TRC AGENDA

**CITY OF DELAND
THURSDAY JULY 20, 2023 AT 1:30 P.M.
CITY OF DELAND TRC MEETING ROOM
DELAND, FLORIDA**

City of DeLand
SP22-215
MAVIS TIRE

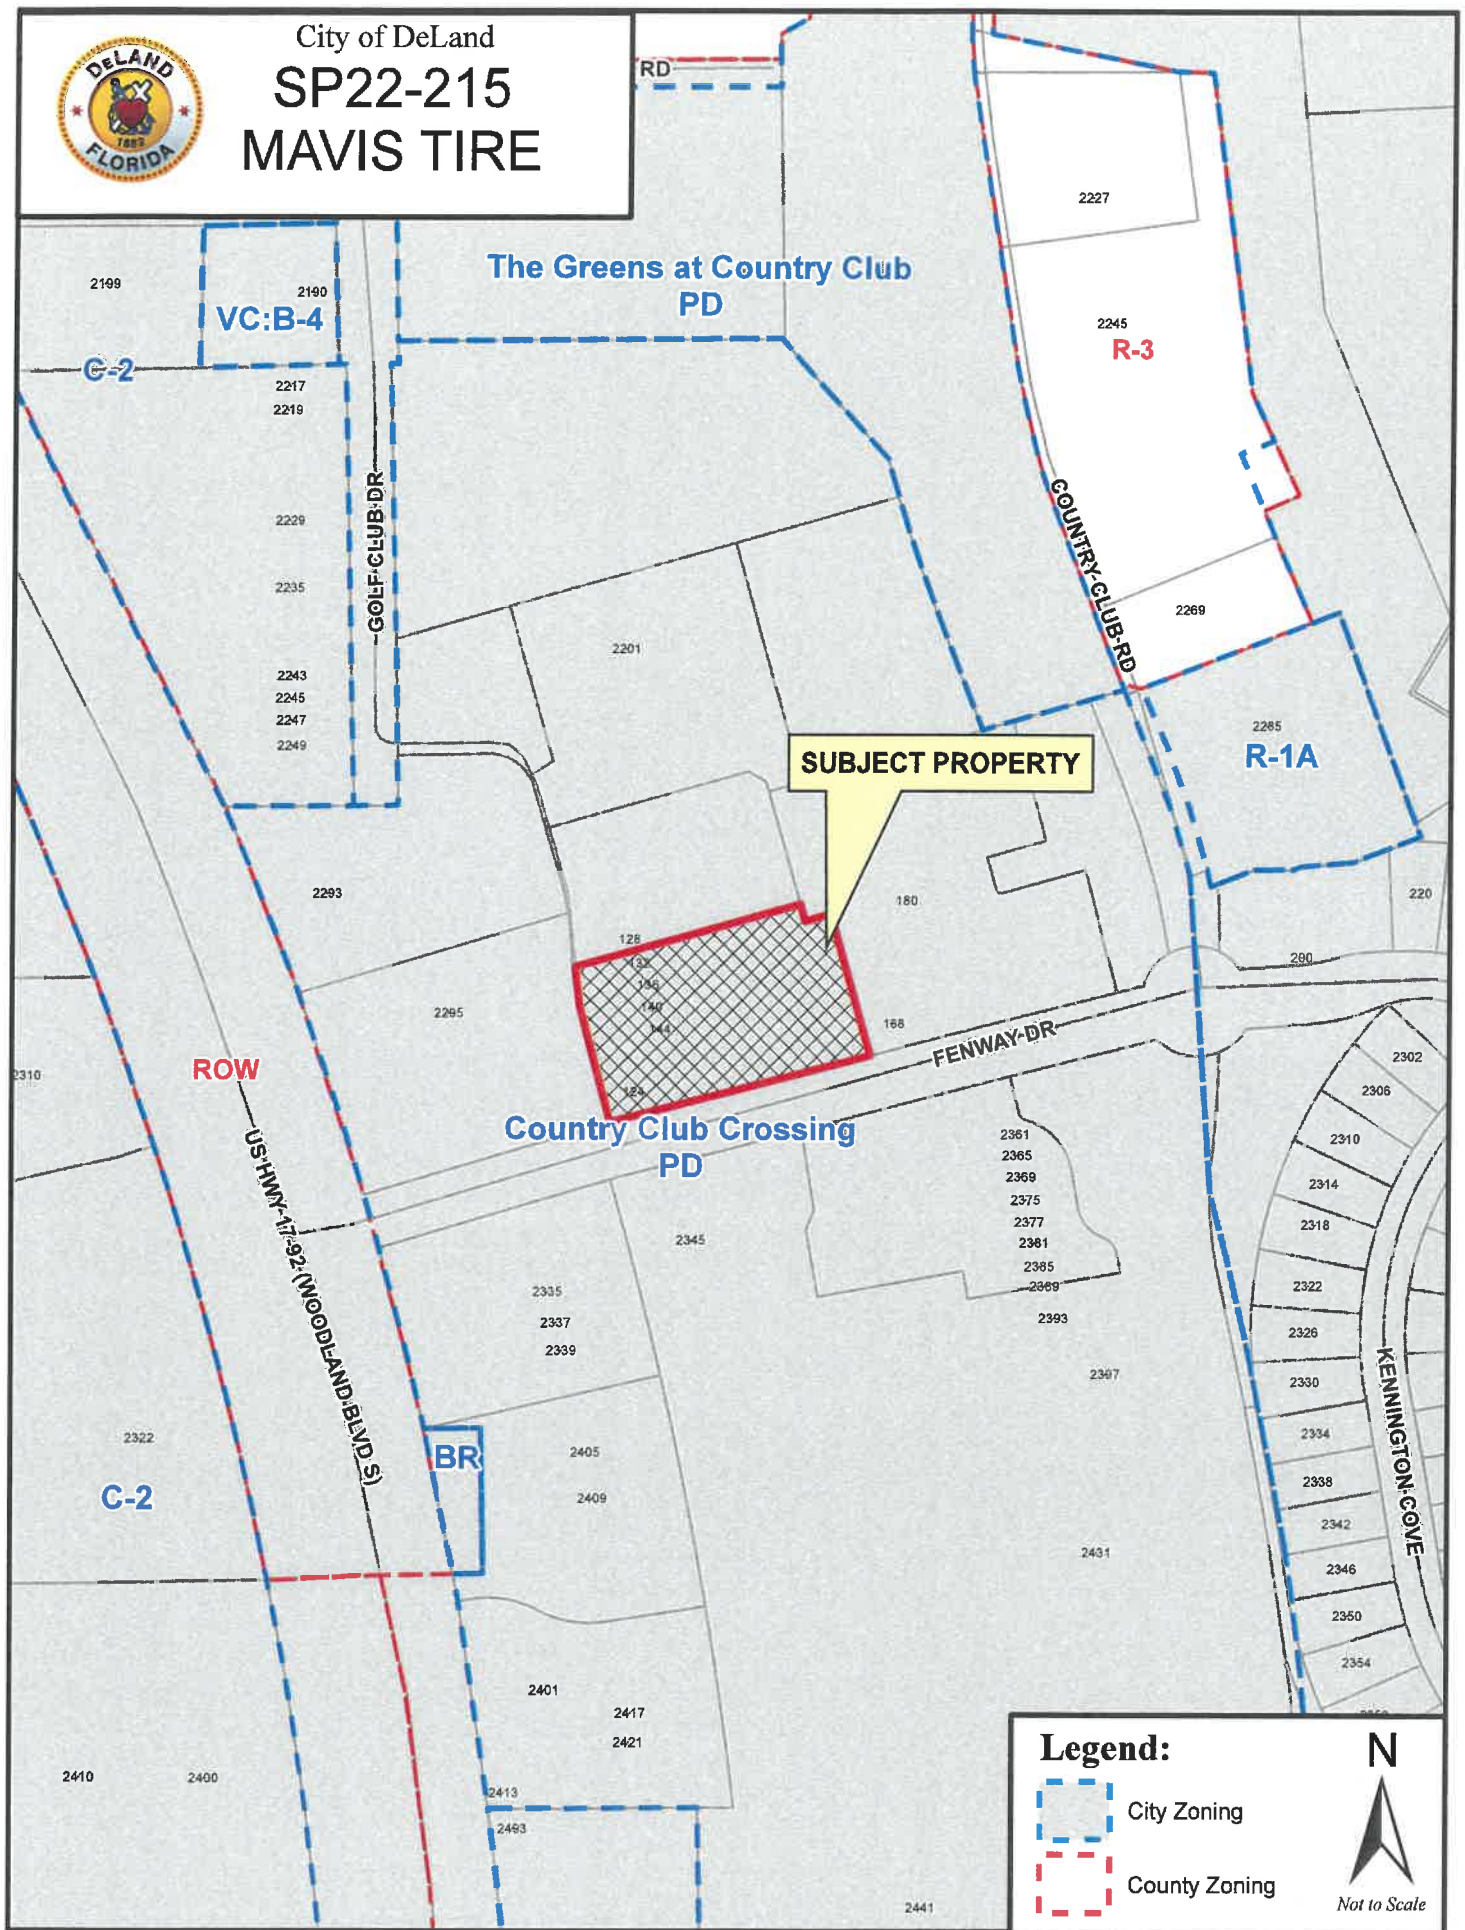
Discipline	Status	Details	Attached To	Created By	Last Updated By	Modifications Required
Insufficient Tree Information Provided						
Please provide tree survey, landscape plan, tree worksheets, tree barricade detail, and irrigation plan. If any Tree Protection Area is on this parcel, please show it on the plan. Sufficient landscaping must be provided per the Country Club Corners PD and mitigation plan.						
Forestry	Not Accepted	Last comment from reviewer: Your current plant list only provides a total of 36" DBH. The lot size requires 121" DBH to meet minimum requirements. You are currently 85" deficient in meeting minimum coverage. The mitigation plan for Country Club Corners Lot 6 requires 416" DBH of canopy trees and 22 palm trees. If you do not wish to plant palms, the mitigation is 6" DBH per palm. The total mitigation would be 548" DBH. If you can meet the minimum requirement of 121" DBH you would be 427" DBH deficient. Last response: Please see revised sheet L-100.	C-101	Mariellen Calabro	Kit Dennis	Yes

Sign details						
Provide details on the monument sign and verify if there will be any additional building signage.						
Planning	Not Accepted	Last comment from reviewer: Sign details depict a 12-foot high pole sign which is not permitted. Per the PD "one outparcel sign per outparcel with frontage on a public right-of-way. Maximum of 48 s.f. per side, maximum of 6 feet in height." The signage will be acceptable once the adjustment is made to comply with the PD agreement. Last response: Please see attached Brand Book HM for sign details.	C-301	Belinda Collins	Belinda Collins	Yes

City of DeLand
PSB23-057
SPRING GARDEN
TOWNHOMES

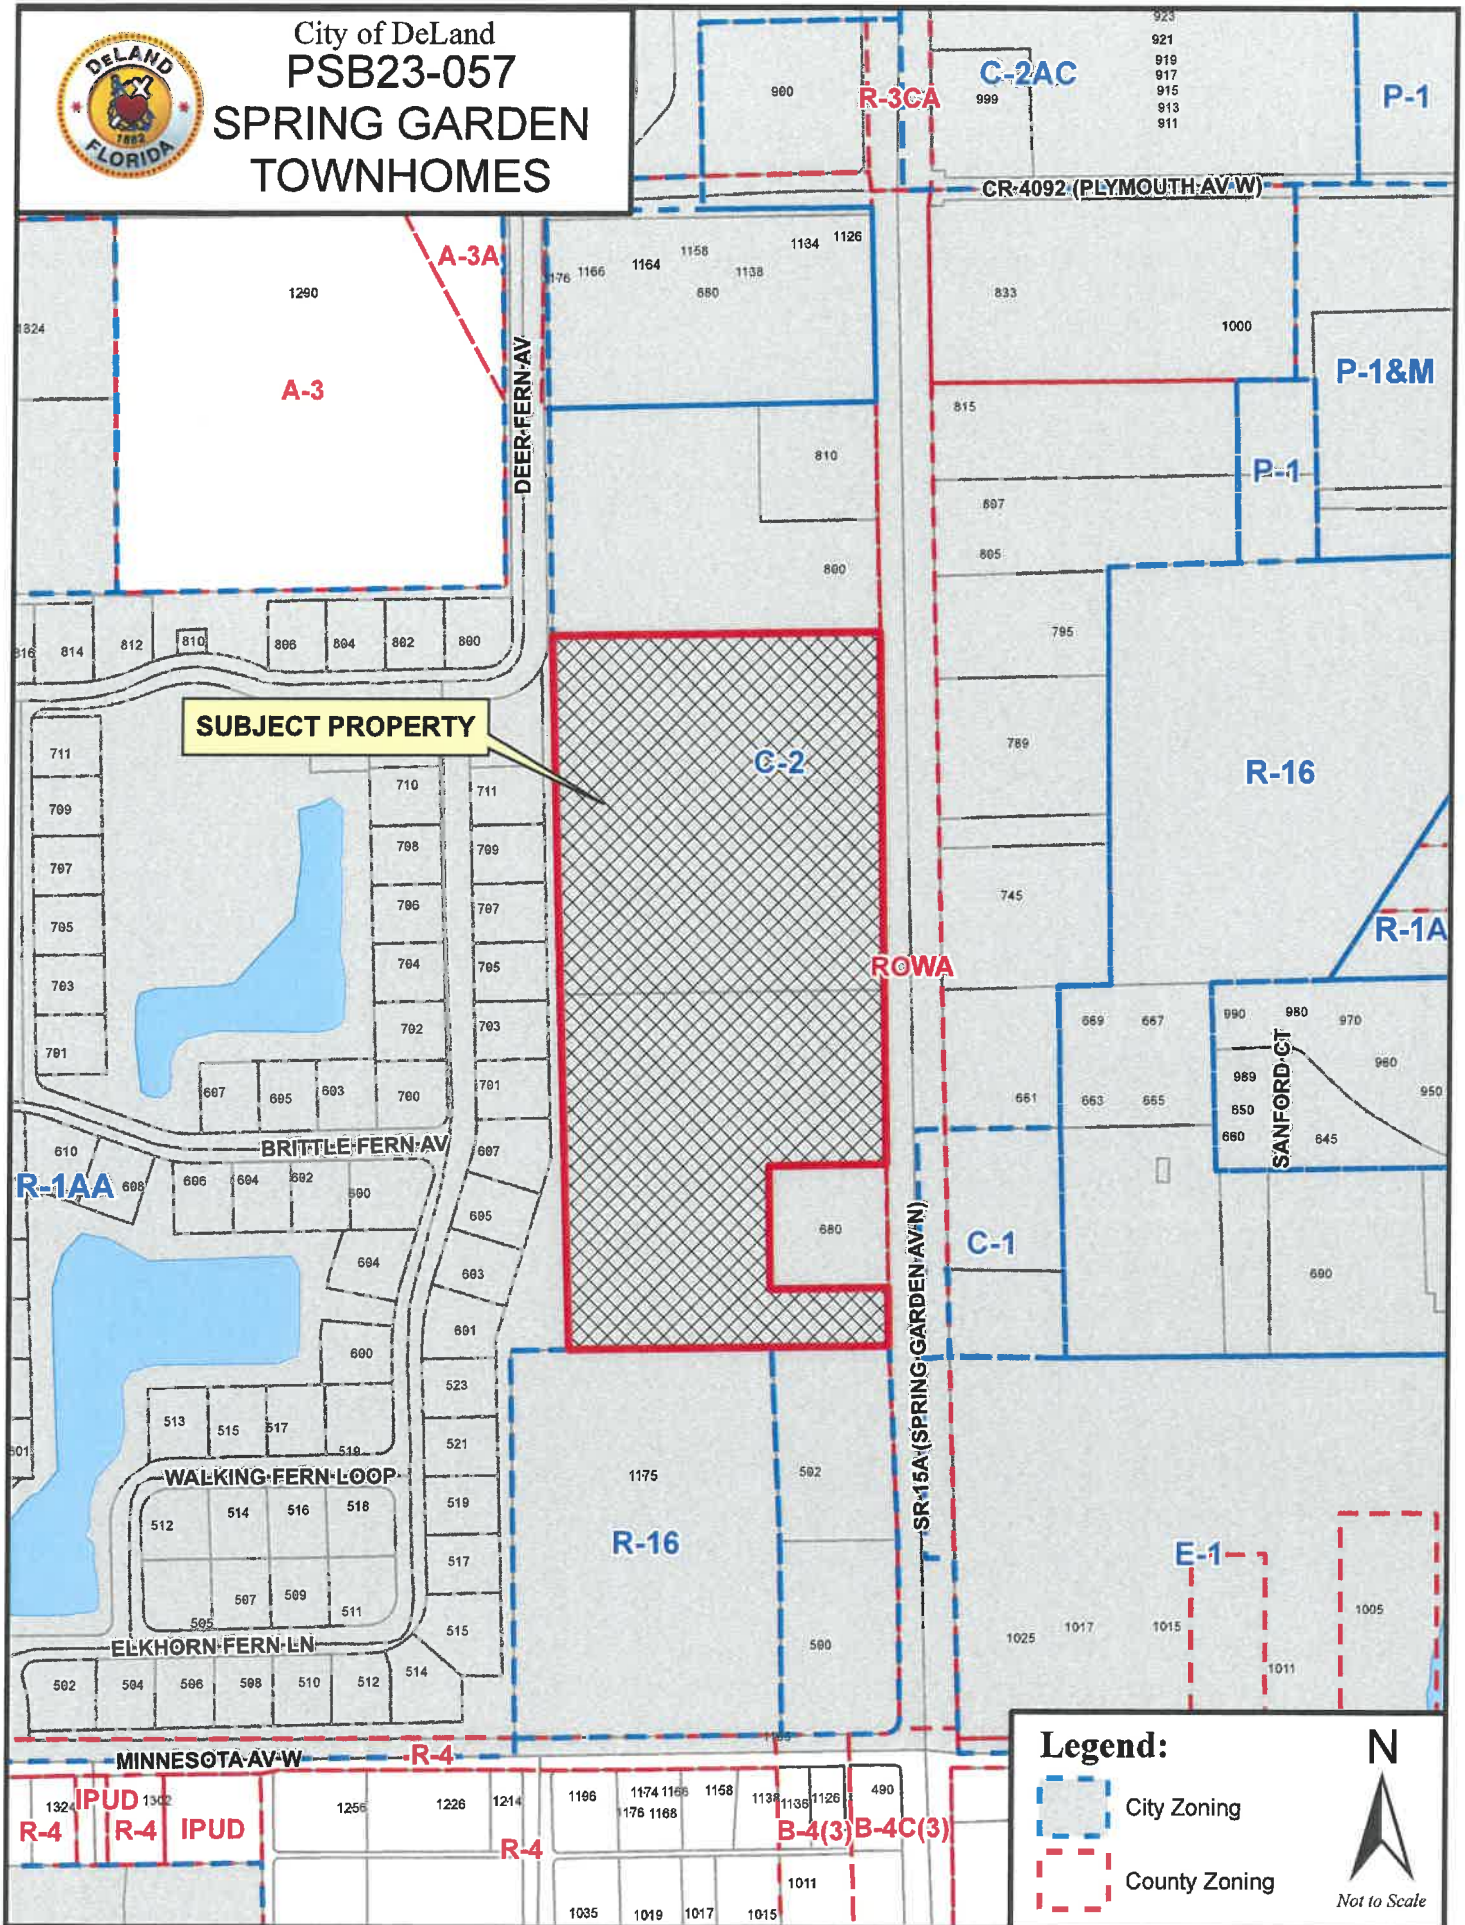
Discipline	Status	Details	Attached To	Created By	Last Updated By	Modifications Required
Reference to VC						
Engineering	Not Accepted	1. Reference to Volusia County needs to be removed since utilities will be provided by City of DeLand.	C4.7	Ray Bahrami	Ray Bahrami	Yes
		Last comment from reviewer: VC references were not removed				
		Last response: Volusia County references were removed.				
Reference to VC						
Engineering	Not Accepted	1. Reference to Volusia County needs to be removed since utilities will be provided by City of DeLand.	C4.6	Ray Bahrami	Ray Bahrami	Yes
		Last comment from reviewer: Reference to VC is still there				
		Last response: Volusia County references were removed.				
Sarasota						
Forestry	Draft	Remove reference to Sarasota County.	C3.2	Mariellen Calabro	Mariellen Calabro	Yes
Tree Protection Areas						
Forestry	Draft	Show Tree Protection Areas on the plat.	2	Mariellen Calabro	Mariellen Calabro	Yes

Note 15						
Forestry	Draft	All plant material substitutions must also be approved by the City Forester.	L2.0	Mariellen Calabro	Mariellen Calabro	Yes
Note 13						
Forestry	Draft	End sentence after the word "Florida" and remove the part that starts with "or to the standards..."	L2.0	Mariellen Calabro	Mariellen Calabro	Yes

7. TYP. TREE PROTECTION						
Forestry	Draft	Replace with City standard tree barricade detail. If you keep the text to the right, change reference to "tree surgeon" to ISA Certified Arborist.	L2.0	Mariellen Calabro	Mariellen Calabro	Yes

Discipline	Status	Details	Attached To	Created By	Last Updated By	Modifications Required
In Note 3 on the third line, insert the word IF between SYSTEMS and UTILITIES						
Planting Specifications -- Tree and Palm Staking						
Forestry	Draft	Update your staking graphics. The hose and wire method of staking can cause damage to trees and is not recommended. Trees should be planted on existing grade and not backfilled with topsoil. Mulch should not be placed on top of the root ball.	L2.0	Mariellen Calabro	Mariellen Calabro	Yes
Mulch						
Forestry	Draft	Mulch should not be placed on top of the root ball of newly planted trees or within 6" of existing trees.	L1.1	Mariellen Calabro	Mariellen Calabro	Yes
Historic Tree Replacement						
Forestry	Draft	The minimum size for historic tree replacement is 6" caliper. None of the trees on your landscape plan are large enough to meet this requirement. If you cannot save the two historic trees proposed for removal, you will need to add sufficient inches in 6" caliper canopy trees to provide sufficient replacement.	L1.1	Mariellen Calabro	Mariellen Calabro	Yes

Project Phasing						
Forestry	Draft	How will this project be constructed? If all landscaping will not be installed prior to the CO on the first set of buildings, please show a phasing plan. All common area and buffer landscaping will need to be installed prior to the first building CO.	C3.0	Mariellen Calabro	Mariellen Calabro	Yes
Tree Barricade detail						
Forestry	Draft	This would be a good place to add the tree layer and tree barricade detail. Rather than circling each tree, you could show tree barricade fencing around the perimeter of the Tree Protection Area.	C3.0	Mariellen Calabro	Mariellen Calabro	Yes
Tree Replacement - Total DBH Protected Tree Replacement Inches						
Forestry	Draft	Based on my calculations (which will most likely change once you revise your spreadsheet), your replacement required will be: Protected trees: 3,451" Specimen trees: 146" Deteriorated Laurel Oaks: 56" Historic Trees (if approved): 53" ----- Total 3,706" DBH Your landscape plan (with revisions) appears to provide 533.5" DBH of trees and 416" DBH of palms. This would leave you 2,756.5" DBH deficient in tree replacement. If you do not plant additional trees, you would need to contribute \$75 per inch not planted into the Tree Replacement Reserve Account. This would result in a \$206,737.50 contribution based on the data provided and suggested revisions.	C2.14	Mariellen Calabro	Mariellen Calabro	Yes

Discipline	Status	Details	Attached To	Created By	Last Updated By	Modifications Required
These numbers will change during your next submission as none of the trees provided in the landscape plan are large enough for historic tree replacement.						
Tree Replacement – Total DBH of Proposed Trees						
Forestry	Draft	I'm not sure where these numbers come from. Your proposed trees would be the trees on your landscape plan, which looks like it will provide 533.5" DBH of trees and 416" DBH of palms. I'm not sure where the 1,589 (1,531) caliper comes from, and your plan doesn't provide 961" DBH of palms. Up to 25% of the canopy tree replacement requirement can be palms; it is not required.	C2.14	Mariellen Calabro	Mariellen Calabro	Yes
Tree Replacement – Other Protected Tree Removal						
Forestry	Draft	Please revise based on comments in tables. It looks like you will have about 10,354" DBH of protected tree removals based on my calculations. Please recheck these numbers once you have made the requested changes as your numbers do not match my calculations.	C2.14	Mariellen Calabro	Mariellen Calabro	Yes

Tree Replacement - Deteriorated Laurel Oaks						
Forestry	Draft	Update based on comments on table. It looks like you will have about 28 deteriorated Laurel Oaks, with a replacement requirement of 56" DBH.	C2.14	Mariellen Calabro	Mariellen Calabro	Yes
Tree Replacement - Specimen Trees						
Forestry	Draft	Update based on revised table. It looks like it should go from 304" to 291" and from 152" to 146" DBH.	C2.14	Mariellen Calabro	Mariellen Calabro	Yes
Tree Replacement - Historic Trees						
Forestry	Draft	Any historic tree removal would be required to be reviewed by the Tree Advisory Committee and approved by the City Commission. This will add at least two months to your project review process. We encourage saving any historic trees that can be saved.	C2.14	Mariellen Calabro	Mariellen Calabro	Yes
Specimen Tree Preservation						
Forestry	Draft	Please update these calculations based on revisions requested for this plan.	C2.14	Mariellen Calabro	Mariellen Calabro	Yes
